Downtown Carpark Site Development

FTAA-2512-1158

2.0 Technical Specialist Memo – Universal Design

Project proposal: Demolition of the Downtown Carpark, and development of the Downtown Carpark site into an integrated mixed-use precinct.

Figure 1: New option for east-west pedestrian connection on Customs Street West

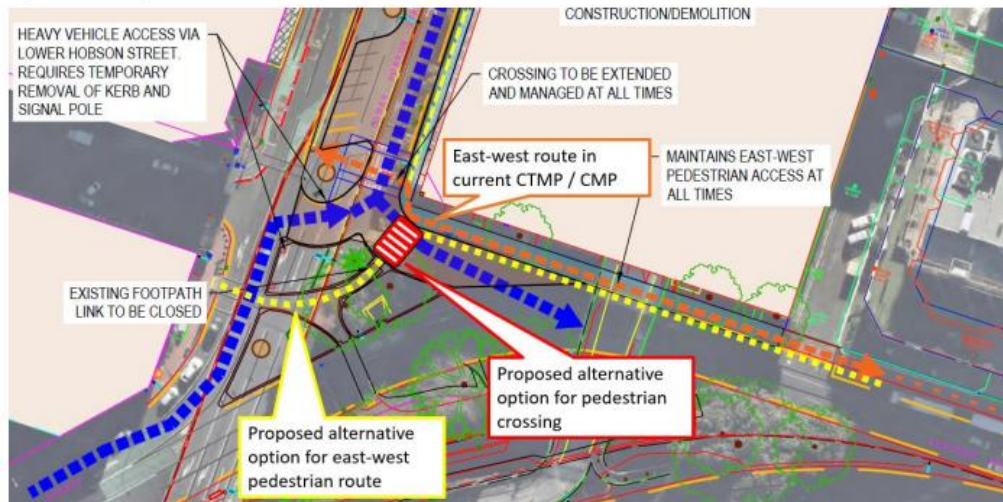
- Overall, the safety plan in place provides sufficient provisions of pedestrian access throughout. The communications protocol is satisfactory with regards to signage.
- I agree with the overall proposal of a new pedestrian crossing along Customs Street West to divert foot traffic indicated in 'yellow' in the above map to potentially reduce vehicle-pedestrian conflict.
- Any certification work related to the proposed pedestrian pathway must be carried out as per condition 23 related to CTMP requiring the consent holder to consult Auckland Transport and Universal design specialists.

- Proposed pedestrian route diversion: There is a proposal to create a new pedestrian crossing location for the east-west pedestrian movement along Customs Street West to ease overlap between construction vehicles and pedestrians. The proposal confirms linking the new route to existing footpaths and signalised crossing point and aims at keeping pedestrians away from Lower Hobson Street slip lane construction zone and from the constrained waiting space underneath the flyover thereby easing the foot congestion.

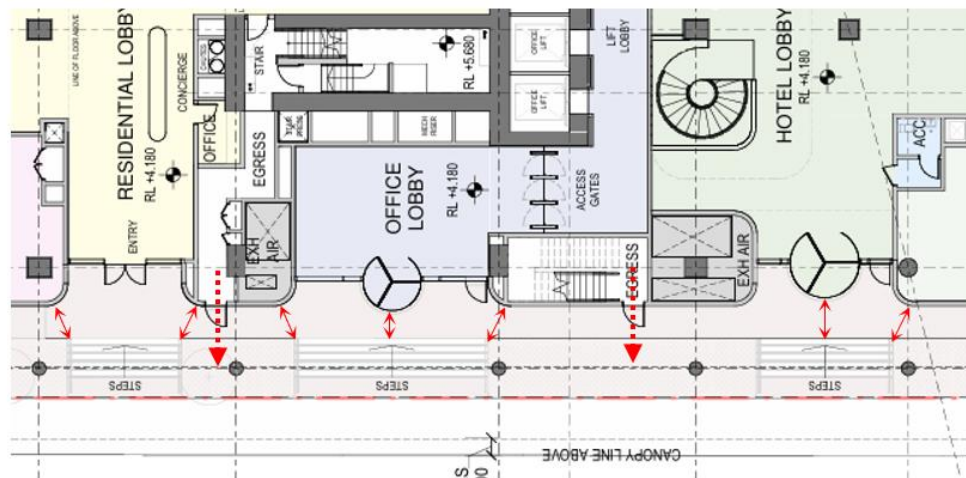
- **Entry points along Lower Hobson Street:** The clear, accessible path of travel in front of the accessible stair connections from Lower Hobson leading to the ground level of P2 remains compromised due to heavy movement anticipated along that path, with access to the residential lobby, office lobby and hotel lobby, all situated along the length. Pinch points and blind spots are formed at the edges of the stairs with rounded off projections reducing visibility. In an event of emergency evacuation, the discharge area in front of both egresses, one from the office lobby and another from the residential lobby, is anticipated to be flooded with people descending the stairwell and subsequently moving across questioning pedestrian safety, particularly for disabled people on the Continuous Accessible Path of Travel (CAPT).

- **Grade separation within Te Urunga Hau (The Urban Room):** A large set of stairs and bleachers significantly reduce pedestrian movement across the entire width of the site, which otherwise had the potential to be an 'at grade' barrier-free movement zone throughout for all visitors.

- **Pedestrian movement along the north-south axis service lane:** Concerns of pedestrian-vehicle conflict based on whether a grade-separation or a shared lane is proposed.

- **Entry points along Hobson Street:** The response maintains multiple entry points from Lower Hobson is a desirable outcome, adding enhanced passive surveillance to the street. Different peak requirements of access into and out of residential, office and hotel lobbies balance the pedestrian flow. Further adding, internal lane networks should provide alternative choices and further balance peak load. Finally, it states that egress widths are more than sufficient to cater to pedestrians in case of an emergency evacuation.

- **Grade separation within Te Urunga Hau :** The applicant acknowledges the above design limitation due to site constraints resulting in a level difference of 4.2m across blocks, and a clear departure from 'at grade' connections required for pedestrians as per the Unitary Plan at this location.

- **Pedestrian movement along north south axis service lane:** The response clarifies that public pedestrian access along north south axis on ground is prohibited and only exists in the basement level resulting in no pedestrian/vehicle conflict.

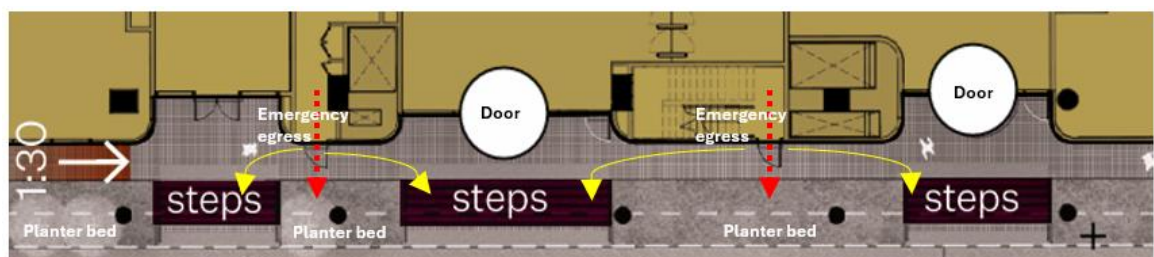
- The design team's response highlighting multiple entry points undoubtedly adds choice of movement for users; however, it does not sufficiently address concerns of pinch points created around emergency egress, as shown below. The dimensions indicated by 'red' arrows in the diagram below remain critical for all times and my concerns for safety, especially in case of an emergency scenario remain in place.

- Emergency evacuations via indicated egresses will direct all building occupants to assemble at Lower Hobson, away from the central court/ Urban Room end, which makes the location and design of all accessible stairs on Lower Hobson critical since all accessible stairs are serving as a means of egress requiring design compliance with NZS 4121:2001 and the NZ Building Code Clause D1/AS1.

- Further, both egresses lead directly to planter beds acting as obstructions further diminishing direct access to street level. In case of a mass evacuation, a 'movement conflict' may likely arise with the

able-bodied moving straight down to access the Lower Hobson via the accessible steps, creating a potential clash with the lateral movement with the wheelchair or pram users and others with mobility issues wanting to access ramps on the north-west corner or south-west end of Hobson Street.

- The gap between the first step and the revolving door of the office lobby seems particularly narrow and insufficient for two-way movement. One solution is to reposition the door and adjacent glazing further back. For accessible space dimension, refer

However, the design team's response indicates a willingness to revisit the accessible stairs' configuration on Lower Hobson for a refined design. My suggestion is to review the stair design in conjunction with all exit points and the external corridor functioning as a CAPT along Lower Hobson. I strongly recommend a review of CAPT by accessibility advocates and input from the fire consultants.

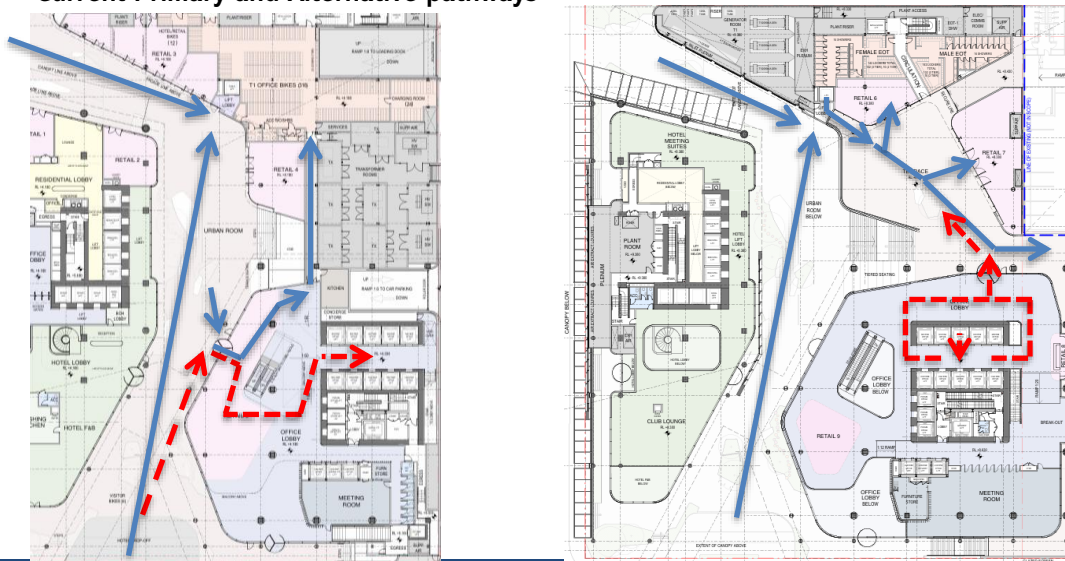
- The design team's response related to legibility of the accessible lift and access through the glass lobby remains unpersuasive. Integration of any lift provision must not compromise visibility and legibility for users. Also, co-location means 'adjacent to a set of stairs/ primary circulation area', therefore, the suggestion is not to create a standalone provision, but rather a centrally placed provision that can easily be spotted, equally by frequent as well as first-time users relying on intuitive wayfinding and minimal signage. Refer to the following plans highlighting the current scenario with an additional alternative pathway shown in 'red' and its comparison to a centrally placed, collated lift with stairs that maximises legibility, effectively reducing the 'red' alternative route.

It may be noted that the building code D: Access also advises lifts must be clearly visible or well-signposted from the building entrance, ideally co-located with stairs to offer choice and meet D1.3.. Refer to <https://www.building.govt.nz/building-code-compliance/d-access/accessible-buildings/internal-circulation/lifts> for design, co-location and visibility of accessible lifts.

- The accessible lift is integrated and incorporated within an adjacent building rather than a standalone element. The glazed enclosure offers higher quality experience with improved safety and surveillance.
- Clear sightlines are available from top and bottom of the public stairs.
- Operated 24 x 7, (hence noted)
- Provision is sufficient and alternative access is only available on weekdays during office hours via P1 commercial lobby

Co-located Acc lift: Reduced alternative pathway & Enhanced Legibility

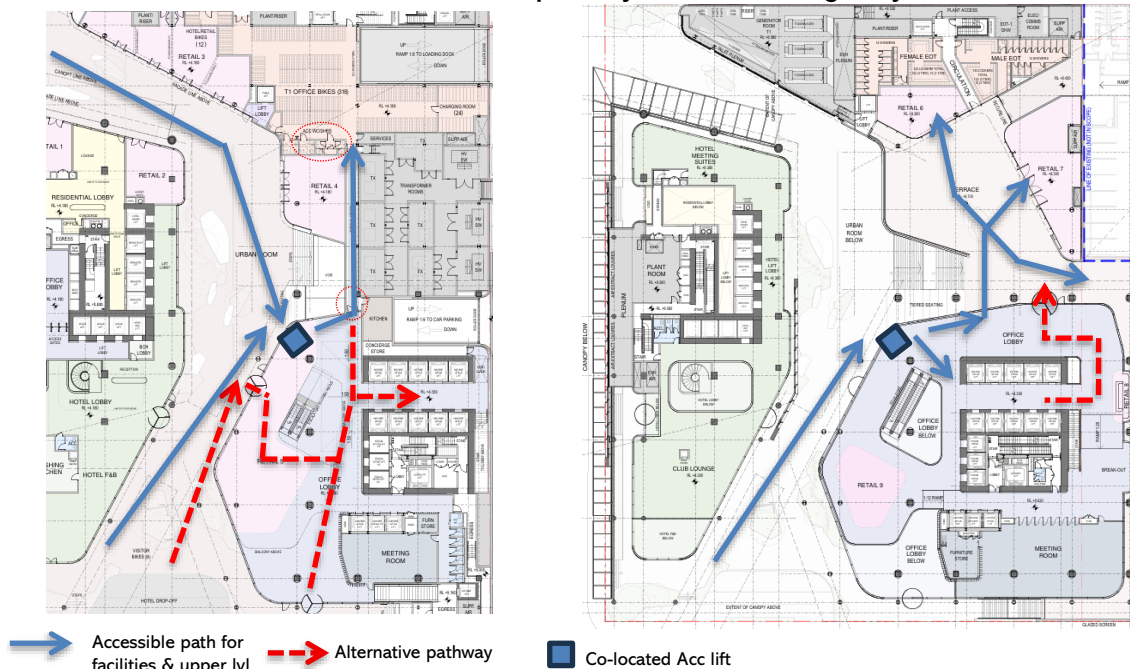
- The comments referring to clear sightlines were in reference to, being able to spot the lift lobby from Lower Hobson Street level and Customs Street West entry points at a human height /eye level, and not from the top or bottom of the stairs. Good wayfinding principle applies from the point of street/site interface onwards.
- There is no anticipated pedestrian traffic data or expected numbers mentioned in the response to support the sufficiency provision of a single public accessible lift operating 24x7 weekdays and full-time during weekends. In my understanding, in an event of accessible lift breakdown and with P1 commercial lobby access not available during weekends and after hours, it may result in mild to moderate connectivity issues. Also, the accessible route maintaining the east-west connection to commercial bay will be compromised.
